- Minor Amendment:
- Site Plan:
    - Revise parking at west site to head in and add 6 stalls.
    - Increase width of drive aisle from 24'-6" to 26'-0".
    - Adjust location of pedestrian crosswalk at north end of site and paint 4" wide strips at 45 degrees 2'-0" o.c.

PROJECT NUMBER: PR-2021-005473

Application Number: SI-2021-00709

## LADERA BUSINESS PARK UNIT 1 - CACTUS PATCH PLAZA

## BLDG B - EXTERIOR ELEVATIONS

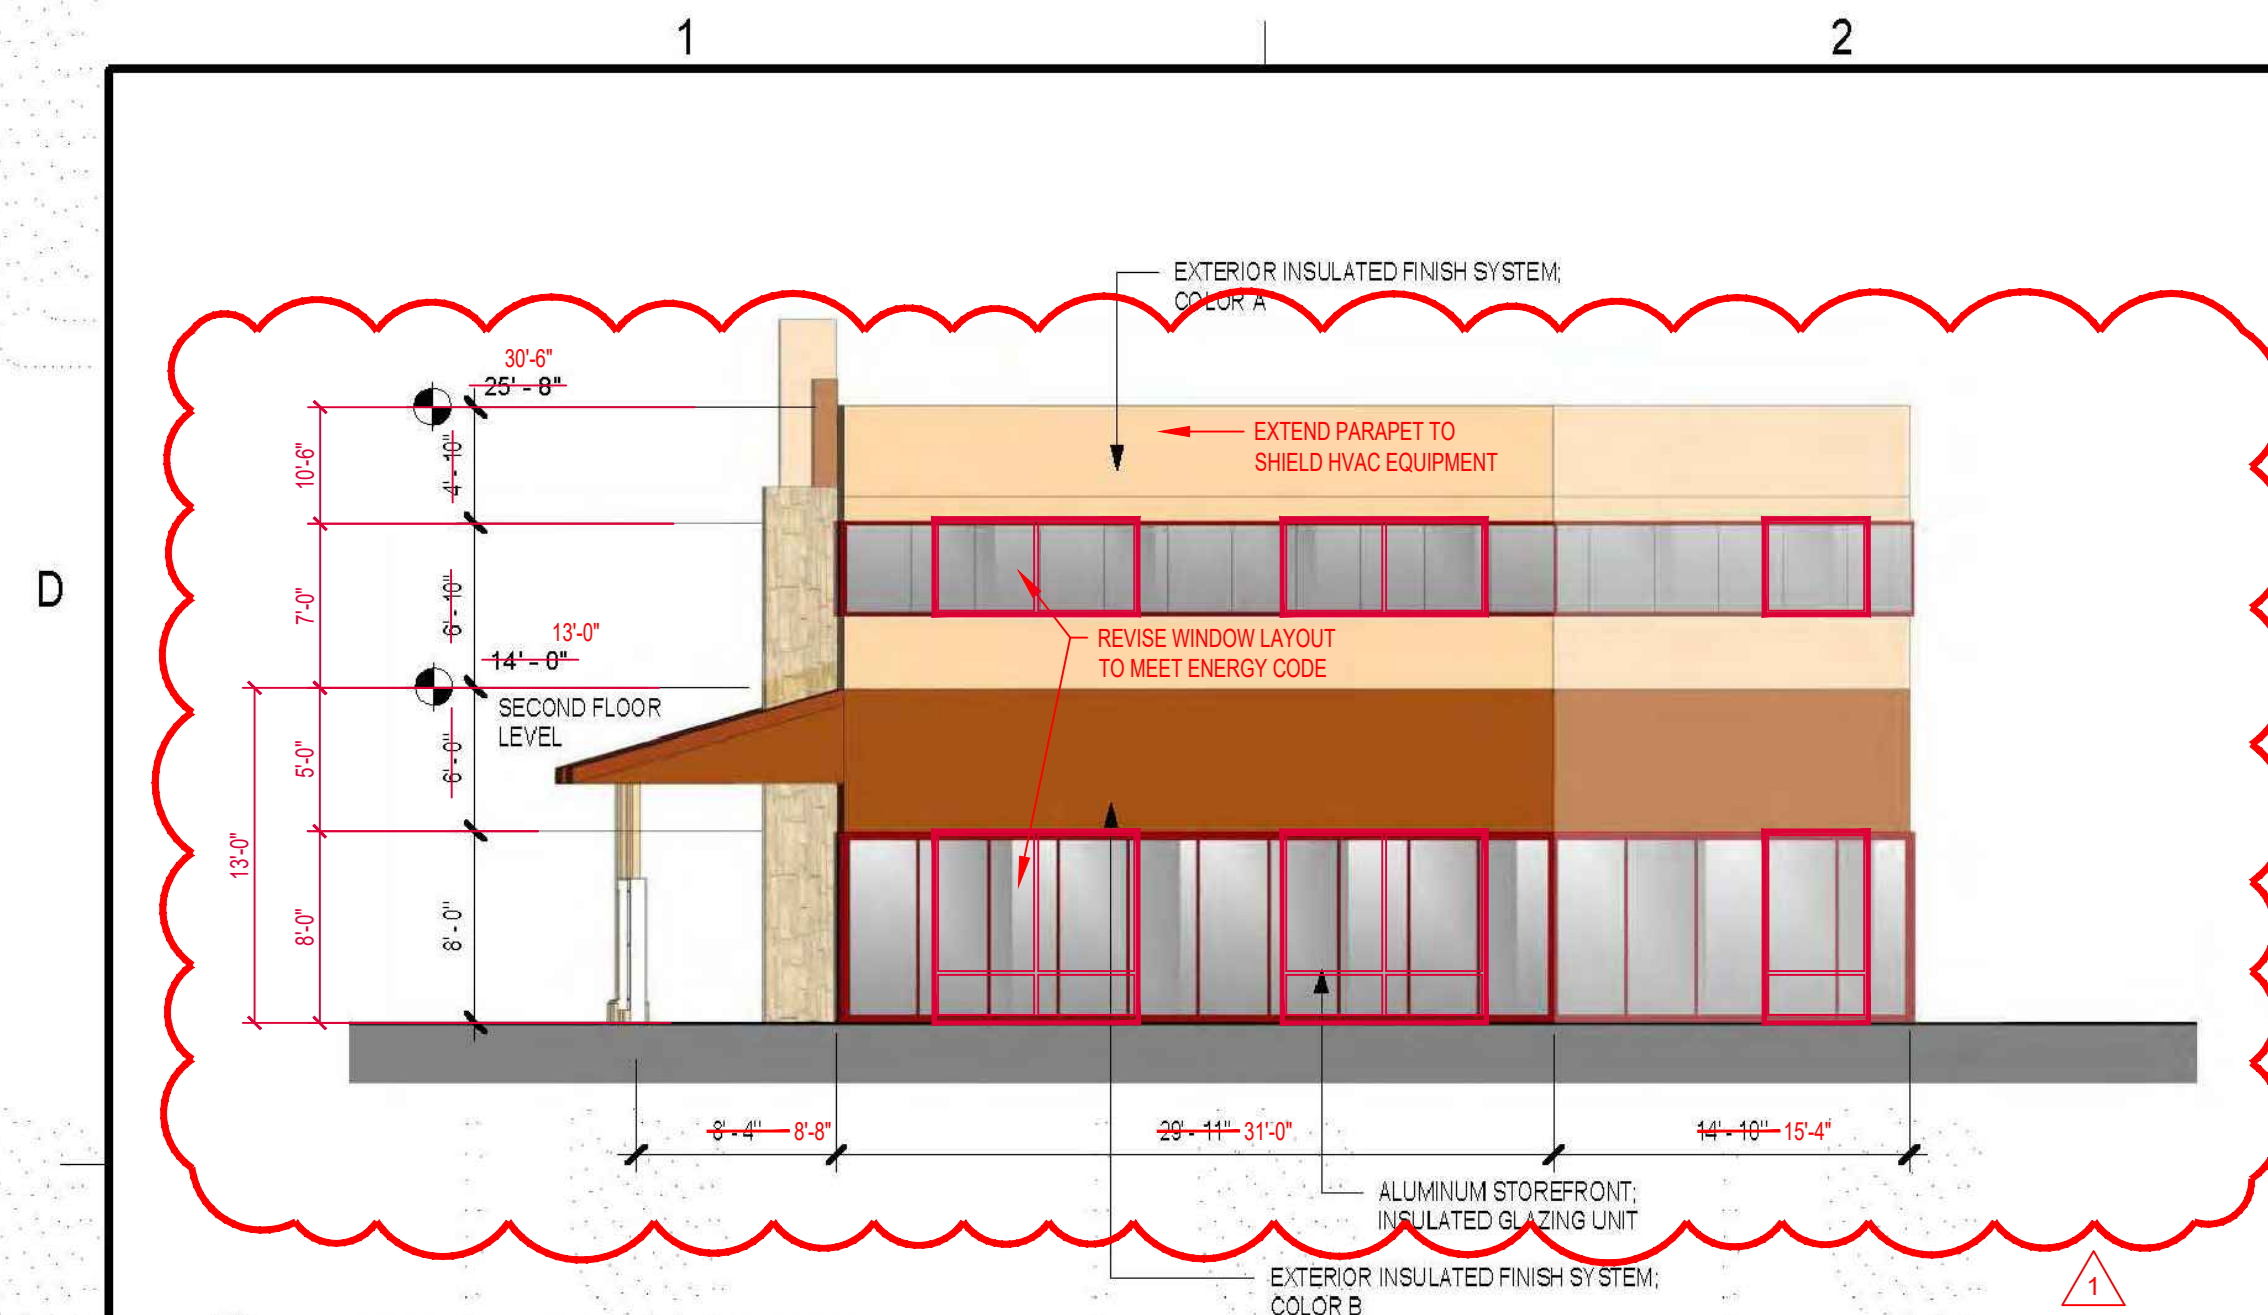
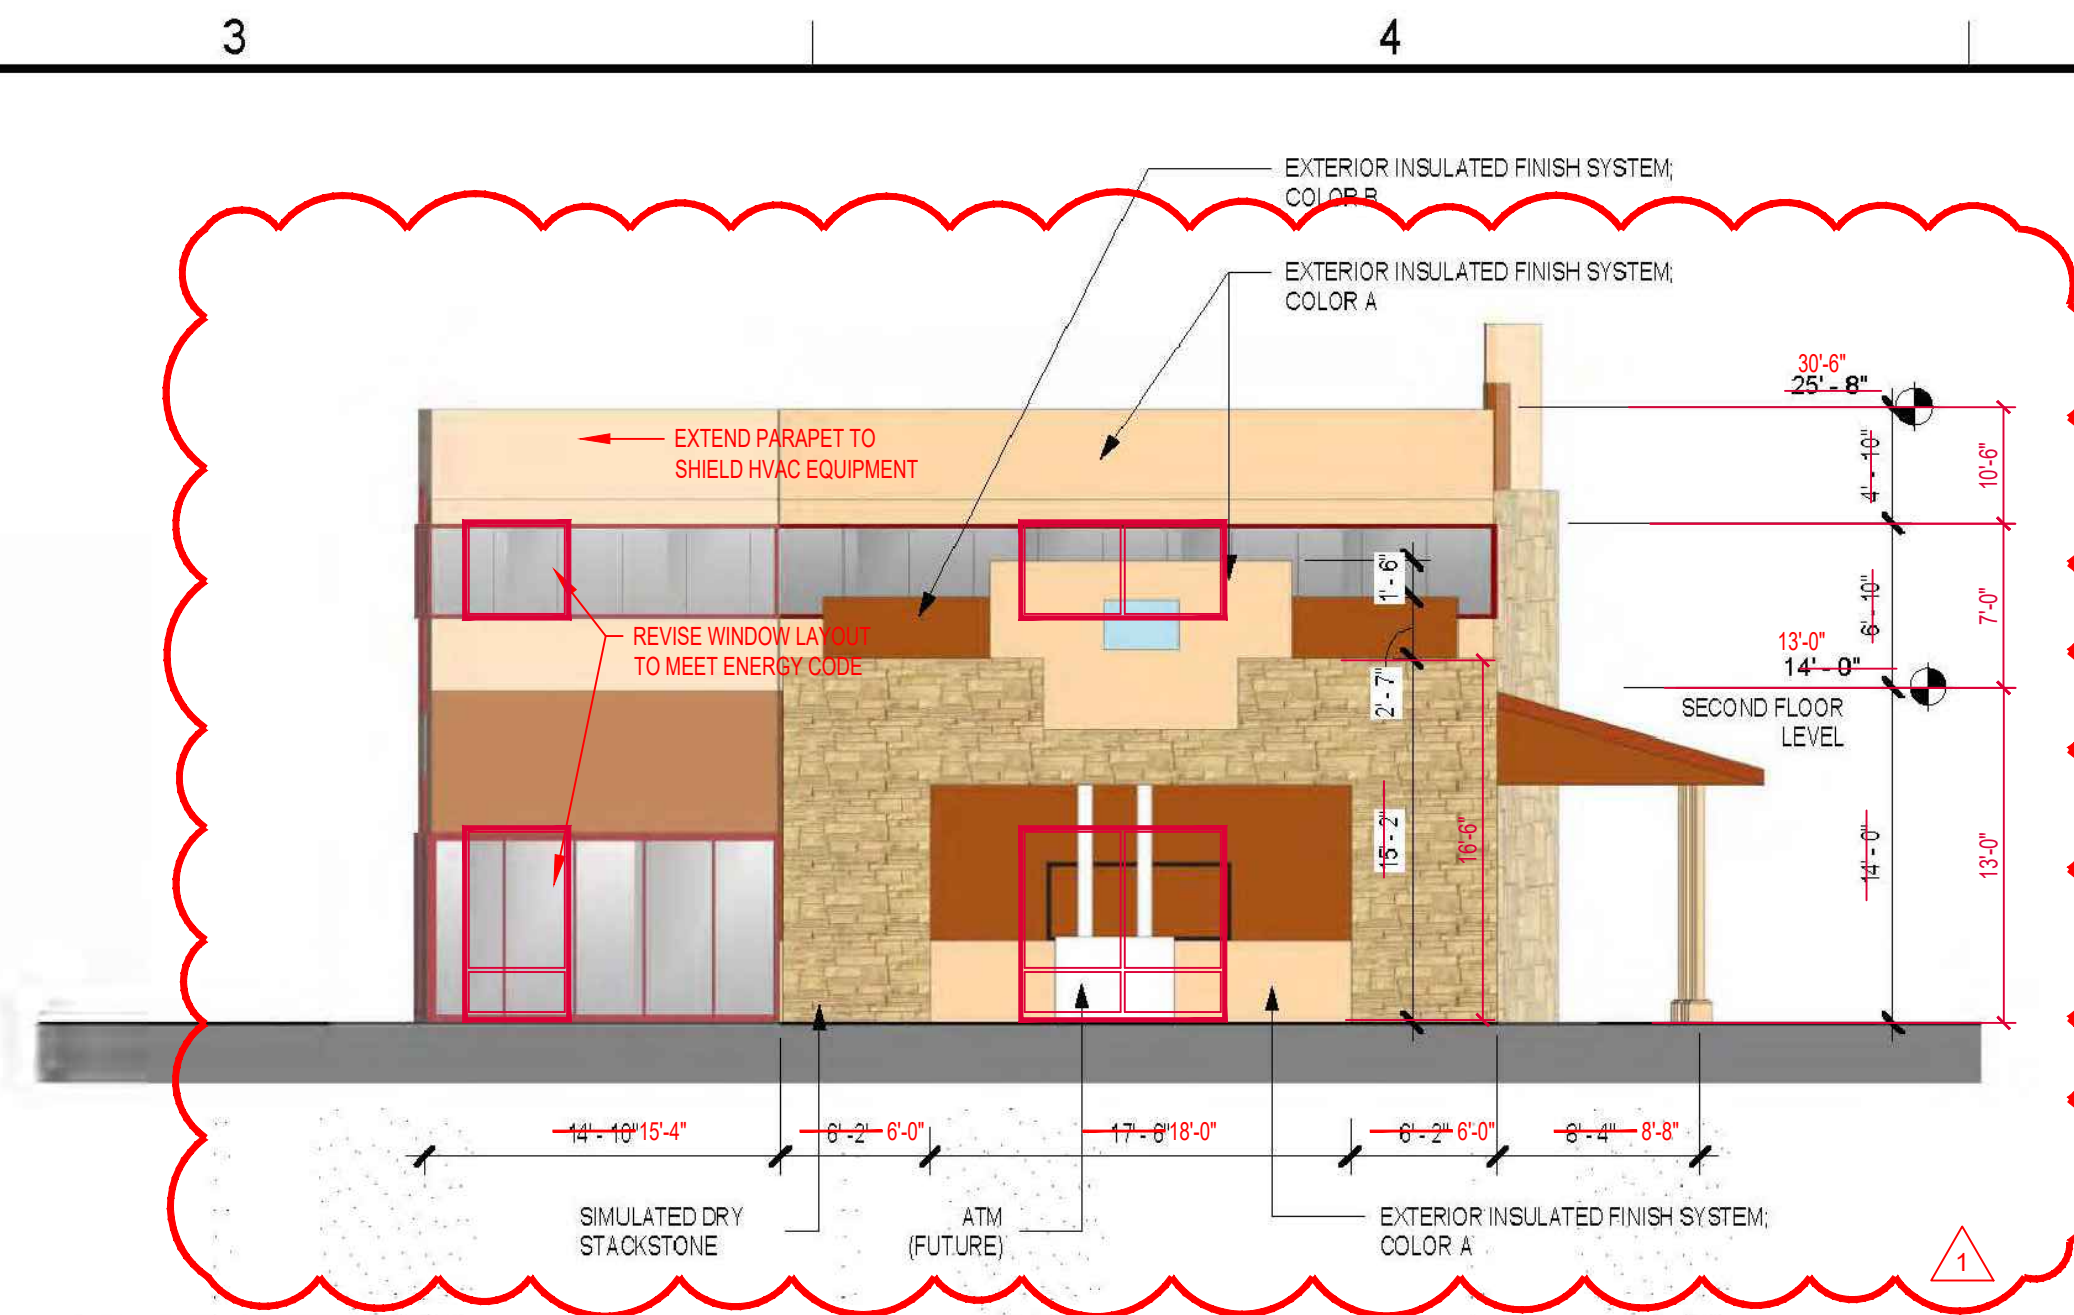
- Building B Elevations:
    - Increase building height from 20'-0" to 22'-0" to provide HVAC screening.
    - Replace CMU veneer with EIFS.
    - Remove awnings at overhead garage doors.

- Add 3'x10' opening in parapet for access for HVAC installation to avoid overhead power lines.
  - Building C Elevations:
    - Increase entry tower building height from 29'-3" to 32'-0".

EXTEND PARAPET TO  
SHIELD HVAC EQUIPMENT

ADDED WINDOW

# BLDG C - EXTERIOR ELEVATIONS

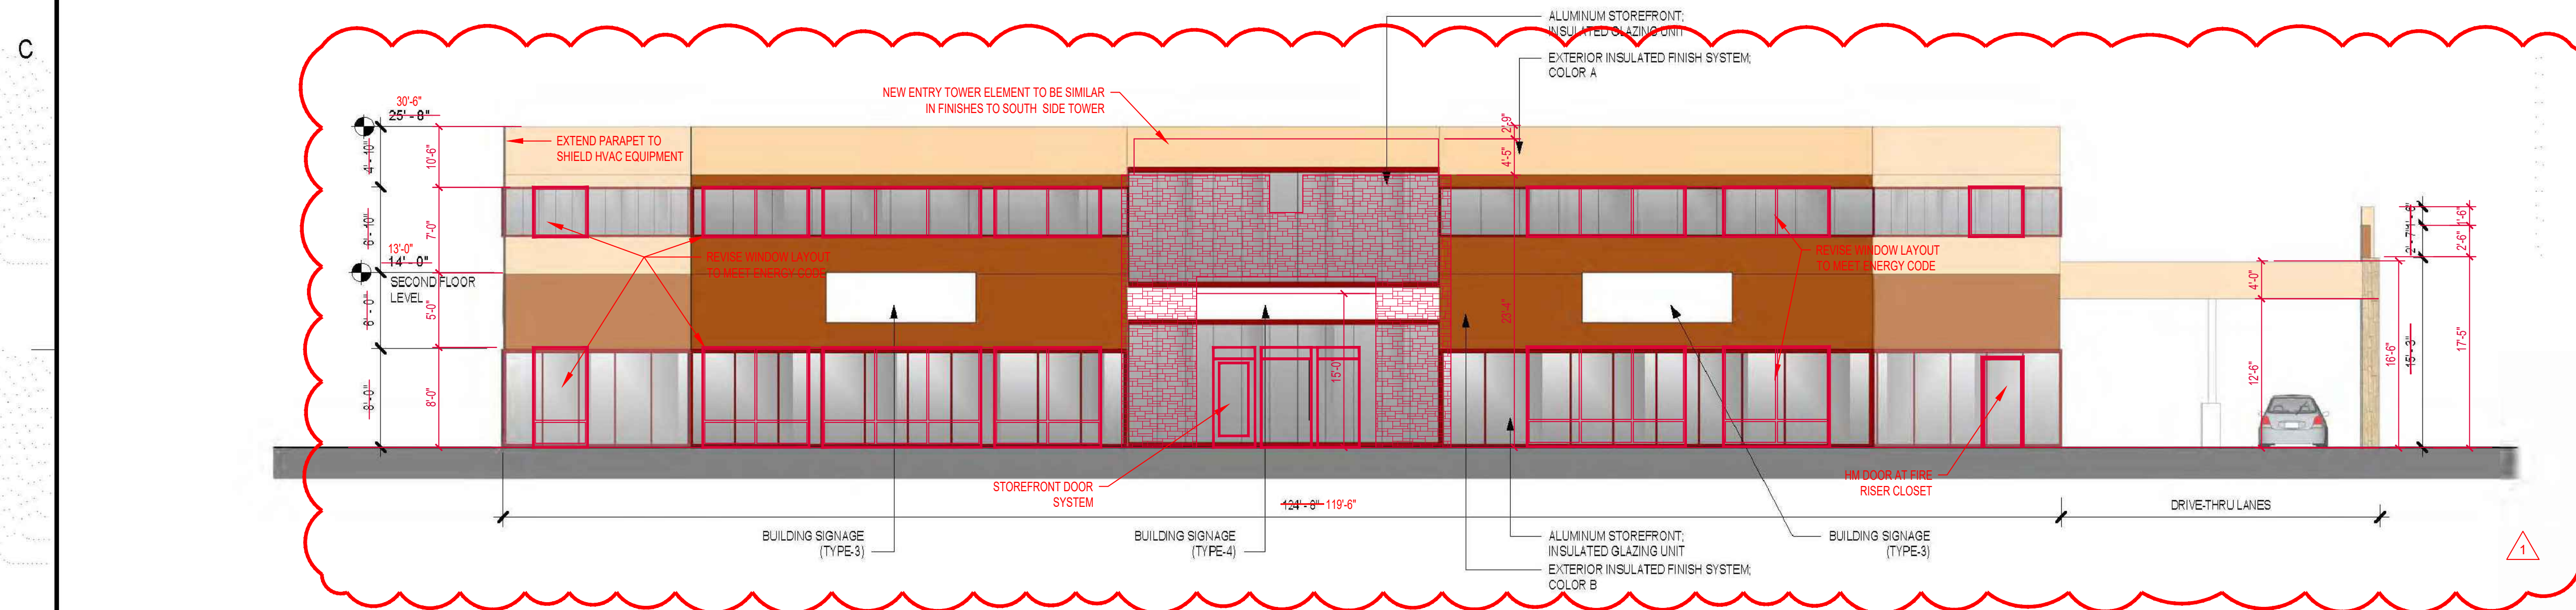
- Increase building parapet height to 30'-6" to provide HVAC screening.
    - Revise window layouts to meet energy code requirements.
    - Add entry element to north side of the building facing the courtyard and building B.
